WILLIAM STREET RESIDENTIAL

ACCESS DESIGN REVIEW – DEVELOPMENT APPLICATION (DA)

164-172 and 174-194 William Street, Woolloomooloo, NSW

Project number: 119744
Revision: ADR 1.0
Date: 23 September 2025

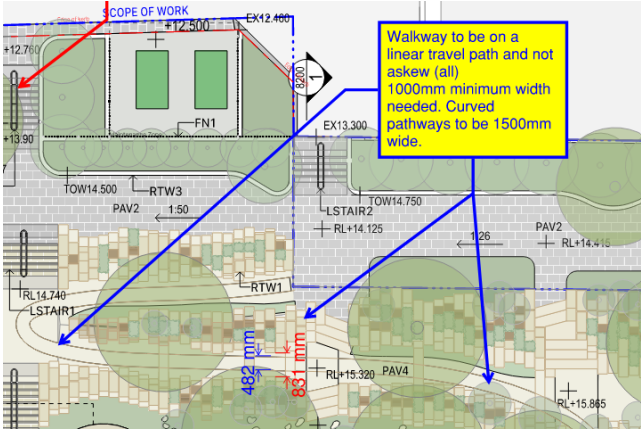
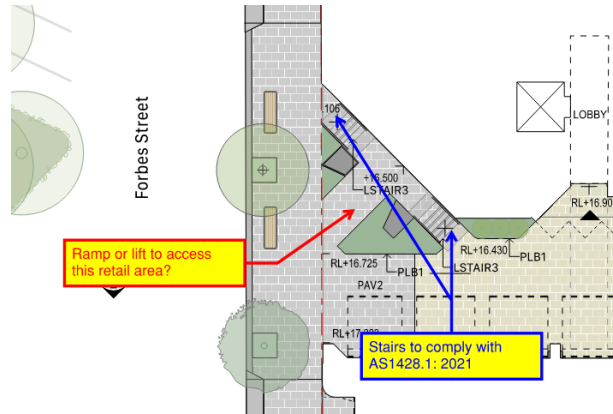
Jensen Hughes has reviewed the drawings and documentation in relation to the specified requirements. Based on the current level of detail, some access requirements, relevant to access to the main entry of the building to the allotment boundary do not fully meet compliance.

As the topography of the site presents mobility limitations to some users with disability, the approach applied by the design team to access the site from Dowling Street is through a Lift in the Dowling Lift building. From the William Street, access to the site is provided from the Lift on William Street East Building.

However, it seems that access to the rest of the buildings on the site is through stairs only. None the less, since the nearest accessible entry points are under a 50 m distance, they are acceptable under the premises standards.

Under the BCA D4D2 (4), at least one floor containing sole-occupancy units and to the entrance doorways of each sole-occupancy unit located on that level should be accessible. **Based on the current design, the SOUs on the Upper ground floor level of William Street West Building do not comply with this requirement, as access is only provided via stairs, with no alternative accessible path of travel such as a ramp or a lift.**

The walkways in the central landscape space on the landscape general arrangement plan required a linear travel path of 1000mm and a 1500mm wide path along curves, and is currently non- compliant

A ramp is required as an alternate path of travel to enter the Forbes Street building as only stairs are provided currently.

Access matters to be addressed: Ongoing review of alternative paths of travel, accessway widths, kerb ramps and ground surfaces as the design continues to develop.

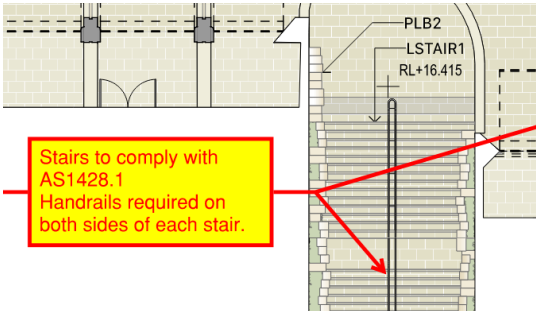
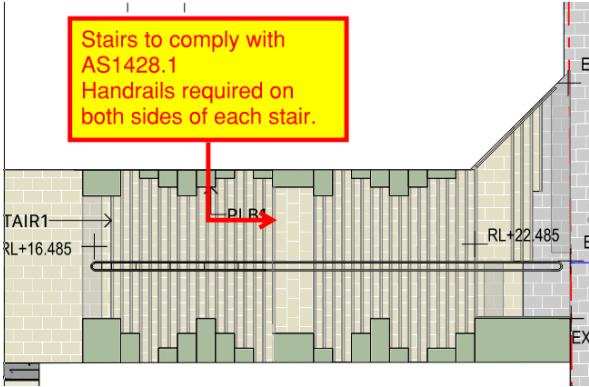
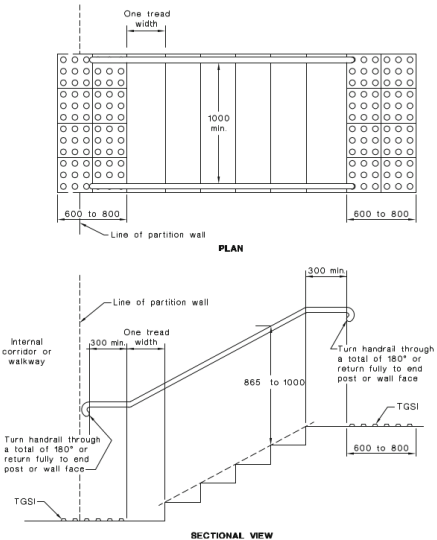
A few ramps and staircases, as listed below require to be offset a minimum 450mm – 600mm to allow for handrail extensions (Jensen Hughes advice a minimum of 900mm, to avoid TGSIs on the pathway)

Location	Non - compliances	References to Australian Standards
Plaza Level- Forbes Street	   	Refer Figure 14 of AS1428.1

Basement 1		Refer Figure 14 of AS1428.1
------------	---	-----------------------------

Some staircases as listed below do not seem to meet compliance in terms of provision of handrails on both sides as shown on Landscape General Arrangement Plan

Location	Non - compliances	References to Australian Standards
Landscape General Arrangement Plan	Staircase west to William Street East building  Staircase north to William Street East building 	Refer Figure 26(B) of AS1428.1

Access matters to be addressed: Assessment of staircase and handrails to comply with AS1428.1, including handrail details, nosing strips, TGSs and required offsets for handrail extensions.

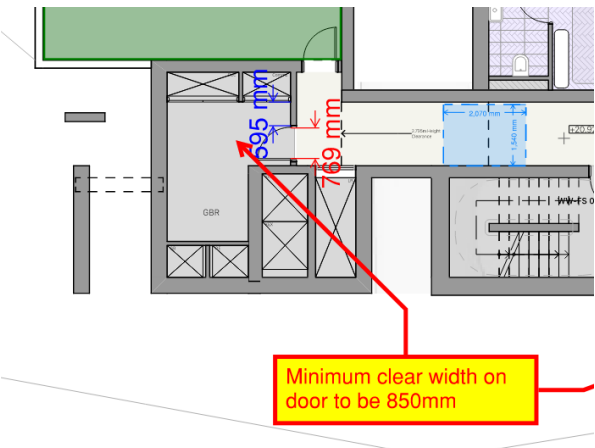
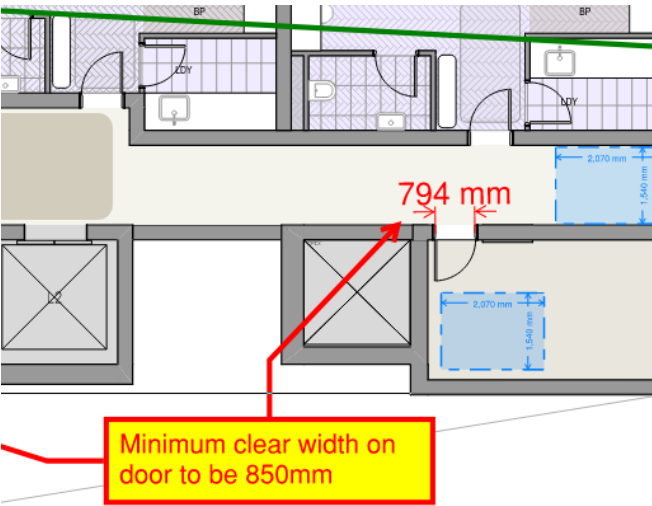
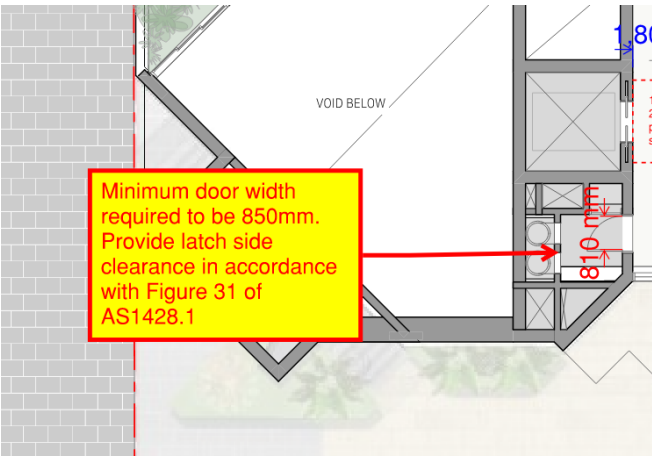
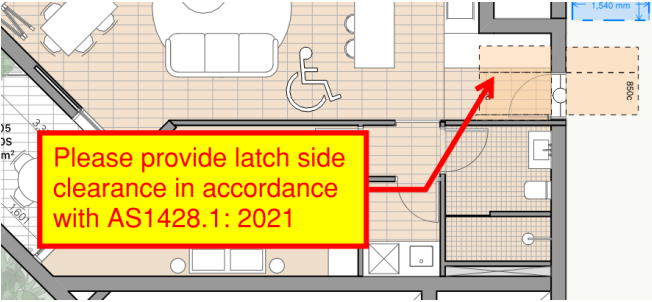
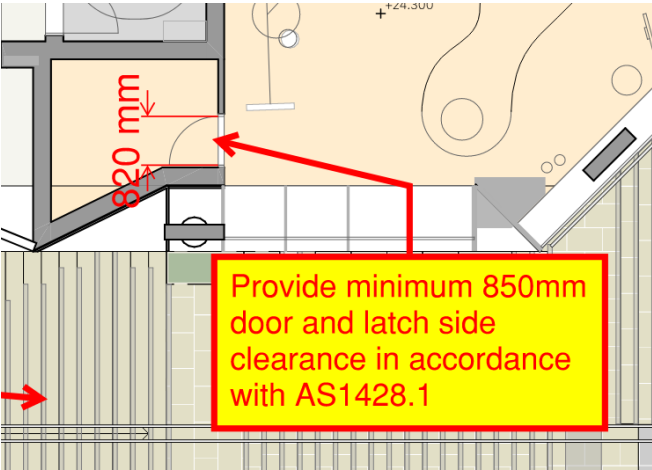
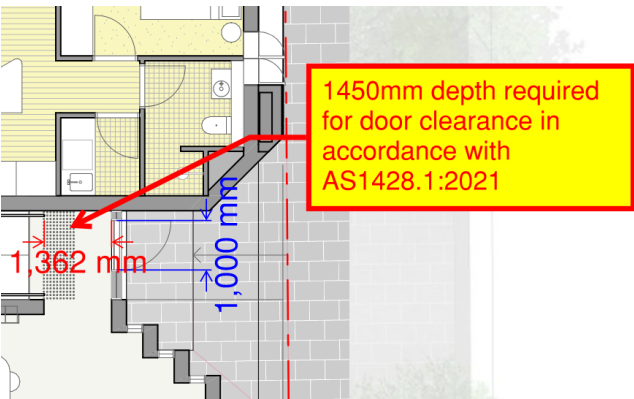
Jensen Hughes has reviewed the drawings and documentation in relation to the specified requirements. Based on the current level of detail, **some doors in the building do not currently have an unobstructed clear width of 850mm and hence do not meet compliance.**

Please see below list of door locations that do not meet compliance in accordance with AS1428.1:2021 in terms of minimum width of 850mm as per Clause 10.2 and door circulation as per Figure 31 and 32 of AS1428.1:2021

Location	Non - compliances	References to Australian Standards																																								
Basement 1		Refer Figure 31 of AS1428.1 <table><tr><th>Dimension D</th><th>Dimension L</th><th>Dimension WH</th><th>Dimension WL</th></tr><tr><td>850</td><td>1450</td><td>0</td><td>510</td></tr><tr><td>900</td><td>1450</td><td>0</td><td>510</td></tr><tr><td>950</td><td>1450</td><td>0</td><td>510</td></tr><tr><td>1000</td><td>1450</td><td>0</td><td>510</td></tr></table> (d) Front approach, door opens away from user <table><tr><th>Dimension D</th><th>Dimension L</th><th>Dimension WH</th><th>Dimension WL</th></tr><tr><td>850</td><td>1450</td><td>110</td><td>530</td></tr><tr><td>900</td><td>1450</td><td>110</td><td>530</td></tr><tr><td>950</td><td>1450</td><td>110</td><td>530</td></tr><tr><td>1000</td><td>1450</td><td>110</td><td>530</td></tr></table> (h) Front approach, door opens towards user	Dimension D	Dimension L	Dimension WH	Dimension WL	850	1450	0	510	900	1450	0	510	950	1450	0	510	1000	1450	0	510	Dimension D	Dimension L	Dimension WH	Dimension WL	850	1450	110	530	900	1450	110	530	950	1450	110	530	1000	1450	110	530

Plaza Level- Forbes Street	 Diagram showing door clearances for the Plaza Level-Forbes Street. A yellow box highlights the minimum clear opening width required for a door is 850mm. For double doors the 850mm width applies to the active leaf. Dimensions shown include 733 mm and 724 mm.	Refer Clause 10.2 of AS1428.1
Plaza Level- Forbes Street	 Diagram showing door clearances for the Plaza Level-Forbes Street. A yellow box highlights the minimum width of door required to be 850mm clear. In a double door, this applies to the active leaf. Dimensions shown include 822 mm, 726 mm, and 1800x2000 passing space.	Refer Clause 10.2 of AS1428.1

Retail Laneway - Dowling Street	 Minimum clear width on door to be 850mm	Refer Clause 10.2 of AS1428.1
Retail Laneway - Dowling Street	 Minimum clear width on door to be 850mm	Refer Clause 10.2 of AS1428.1
Retail Laneway - Dowling Street	 Minimum door width required to be 850mm. Provide latch side clearance in accordance with Figure 31 of AS1428.1	Refer Clause 10.2 and Figure 31 of AS1428.1

Access matters to be addressed: Assessment of non-compliant doors in relation to the required clear opening widths.

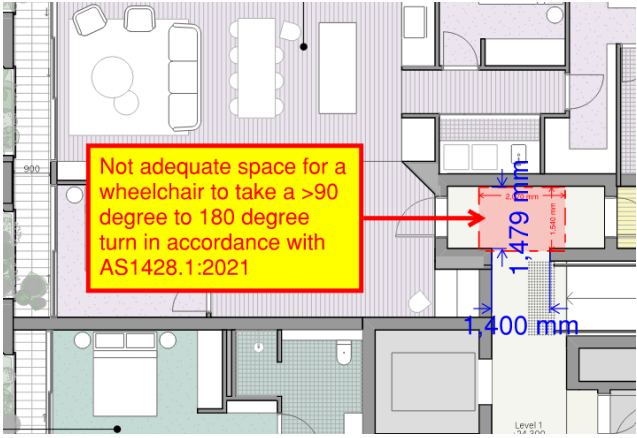
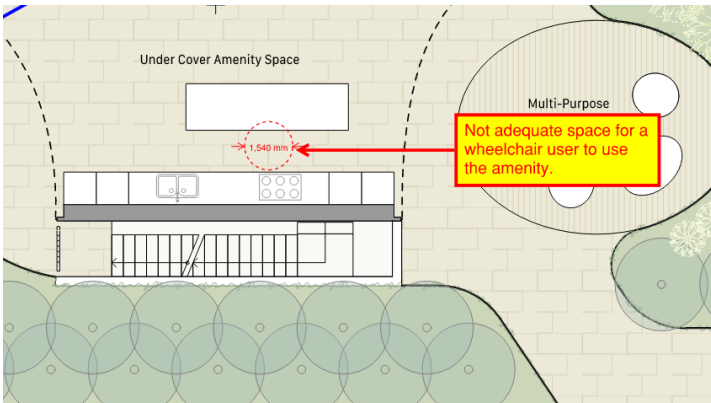
Jensen Hughes has reviewed the drawings and documentation in relation to the specified requirements, A 1000mm clear width passage is available connecting most of the communal use spaces in the building.

Location	Non - compliances	References to Australian Standards
Basement 01		Refer Figure 3 of AS1428.1  
Basement 01		Refer Figure 3 of AS1428.1

Upper Ground Floor – William Street		Refer Figure 3 of AS1428.1
Level 9		Refer to AS4299.1995
